Work Order ID 86319

Item Name: Step Modification

DART SERVICE INSTRUCTION

TO AMEND DRAWING D350-591 REV. F

FIGURE 1 - CLAMP/CUSHION INSTALLATION

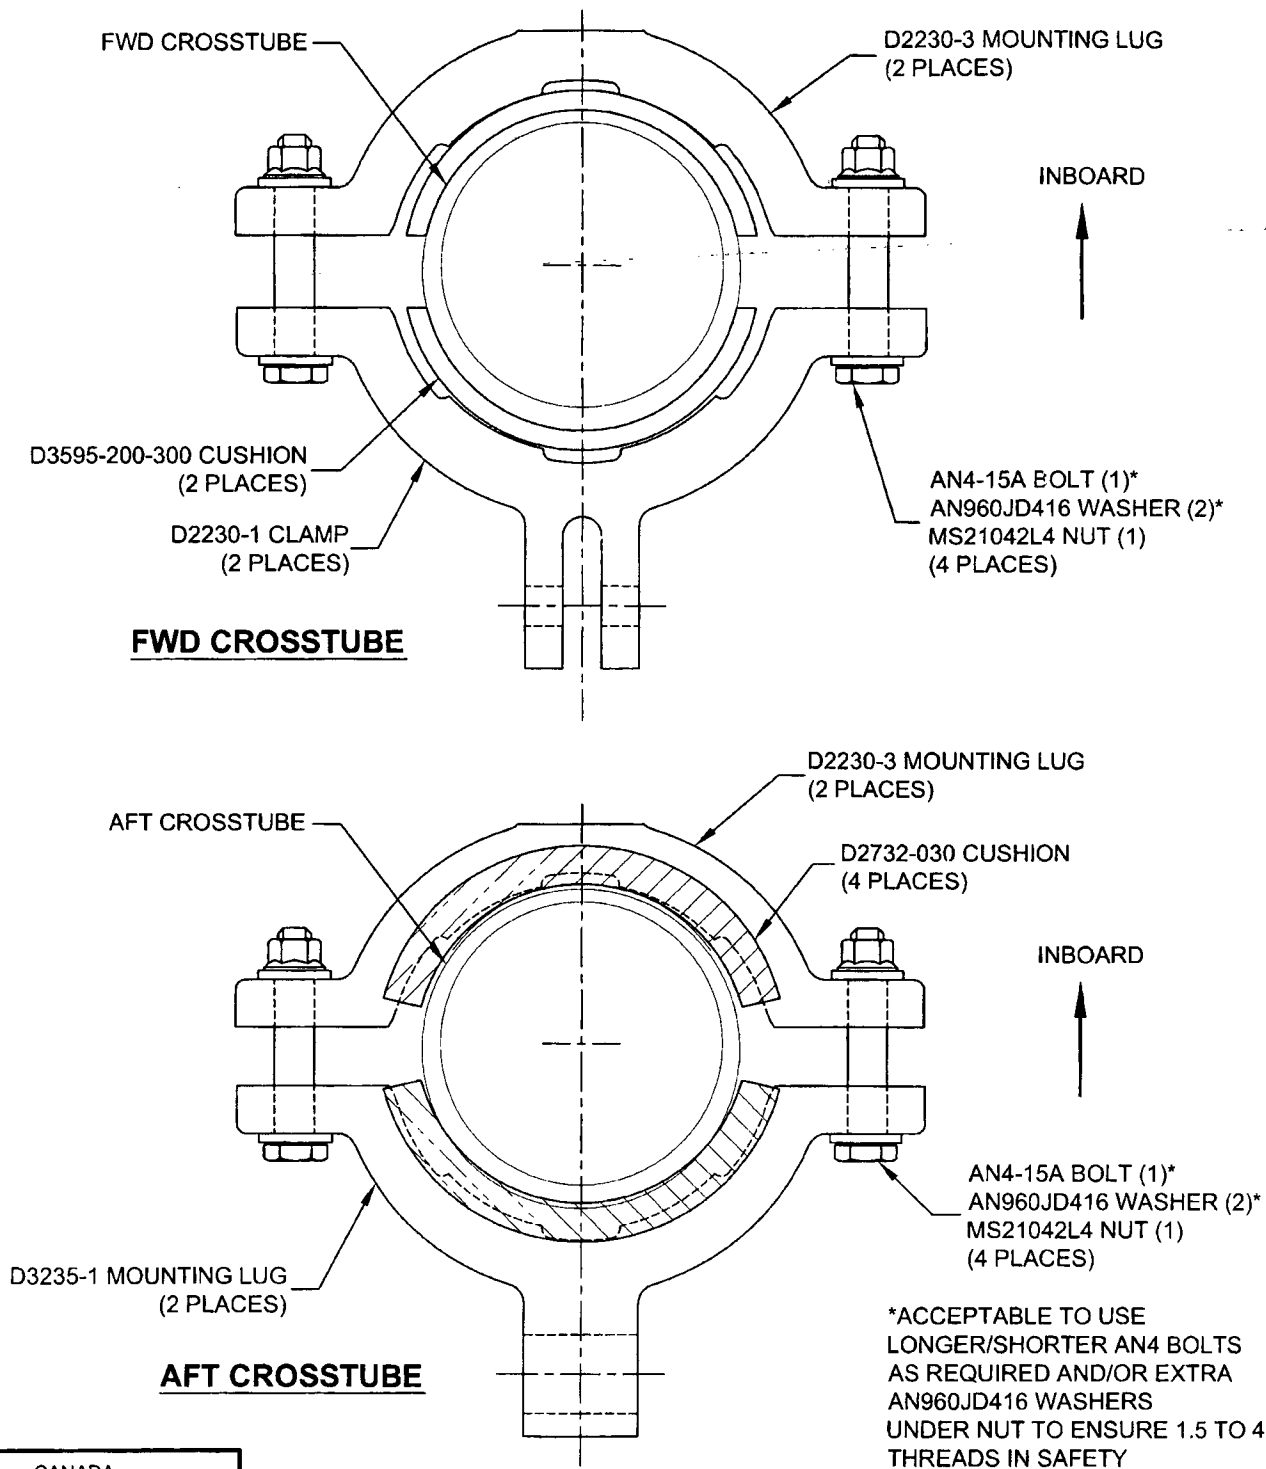
TO IMPROVE THE FIT OF THE D350-591-311/-312 STEPS, IT IS ACCEPTABLE TO INSTALL THE DSI 9410-011 KIT. INSTALL THE D2732-030 CUSHION (AFT CROSSTUBE) AND D3595-200-300 CUSHION (FWD CROSSTUBE) AS SHOWN IN FIGURE 1 IN PLACE OF THE D2856-400-720 ABRASION STRIP CALLED OUT ON DRAWING D350-591 REV. F.

FOR CUSTOMERS WHO HAVE PREVIOUSLY INSTALLED D2856-400-720 ABRASION STRIPS REMOVE THE ABRASION STRIPS IN ACCORDANCE WITH ICA-D350-591. PRIOR TO INSTALLING THE DSI 9410-011 KIT.

DSI 9410-011 KITS WILL BE INCLUDED WITH D350-591-311/-312 STEPS AT CHANGE 002 AND SUBSEQUENT.
